## PRODUCT ADVISORY NOTICE

PAN/23-02

**Product Line:** VisionMaster FT & VisionMaster FT Navalised Display

**Hardware:** Radar, ECDIS and TotalWatch

Figure 2: Error dialogue

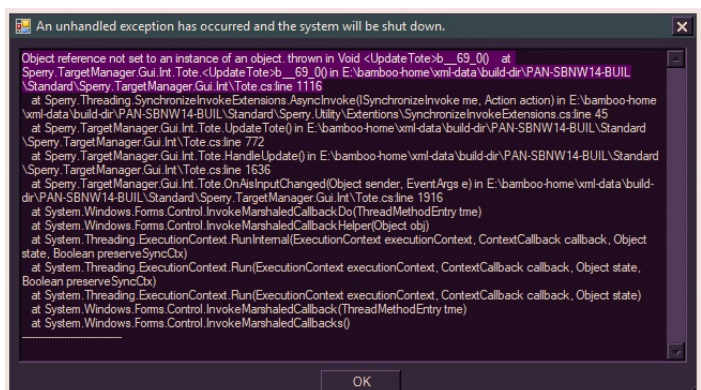
The issue occurs infrequently when a single AIS target goes out of range, but can be more frequent in cases 2 and 3. When the issue does occur, a dialogue will be seen on the screen with the title *"An unhandled exception has occurred and the system will be shut down"*, similar to the image to the right.

The equipment will then stop working and should be manually restarted.

**Note:** It is the act of deselecting 'Enable Input' for 'AIS Display' that may cause the issue. A system with the 'Enable Input' permanently deselected will not experience the issue.

If you experience the issue, in the first instance you should restart the system and continue navigation.

To reduce the possibility of the issue re-occurring, the following user settings can be considered as a temporary workaround until the software update addressing the issue is applied:

- Where practical, ensure the Selected Target does not go out of AIS range <sup>4</sup>
- Permanently deselect the 'Enable Display' setting for 'AIS Display' on the Targets | AIS Display menu
